C-E POWER SYSTEMS
COMBUSTION ENGINEERING, INC.

RESPONSE TO NRC QUESTIONS ON
THE CALVERT CLIFFS UNIT I
CYCLE 4 RELOAD SUBMITTAL APPENDIX
1-NP, APRIL 25, 1979

DOCUMENT NUMBER: CEN 107-(B)-NP

Figure 1

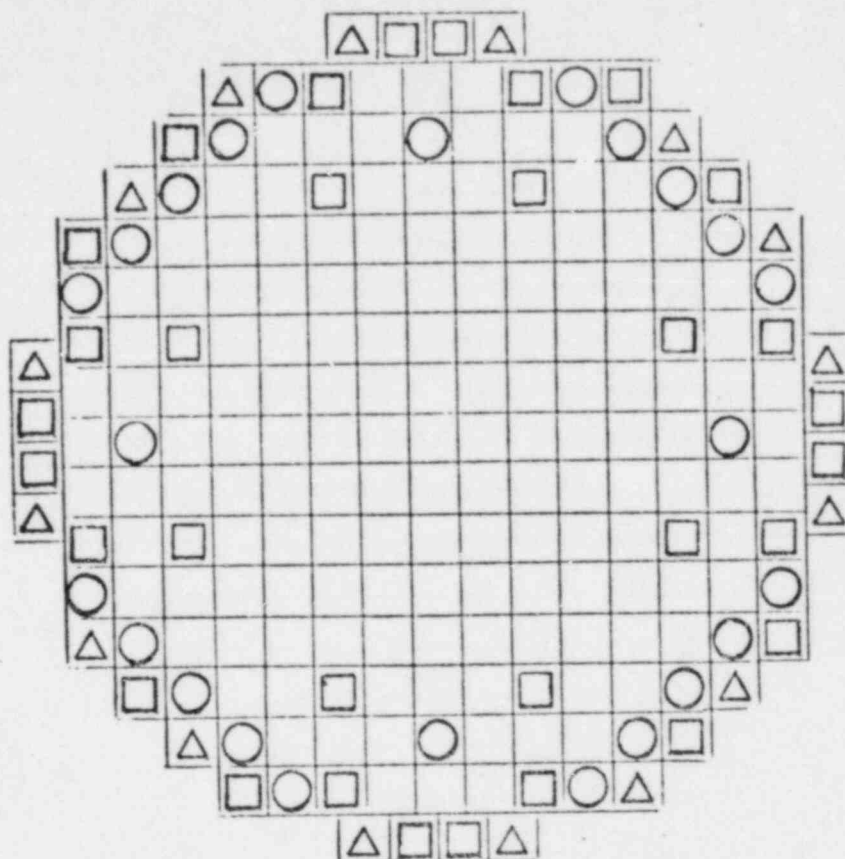
Question 4: Of the 56 Batch F fuel assemblies not installed under CEA's identify (core location) which of these assemblies are sleeved and which have the []?

Response: The distribution of the Batch F fuel assemblies is shown in Figure 1. In summary, this figure shows:

- 24 Batch F assemblies under CEAs all of which are sleeved
- 16 Batch F assemblies with []
- 32 Batch F assemblies with [] no sleeves

Please note that there are 48 Batch F fuel assemblies not installed under CEAs, rather than 56 as noted in the question.
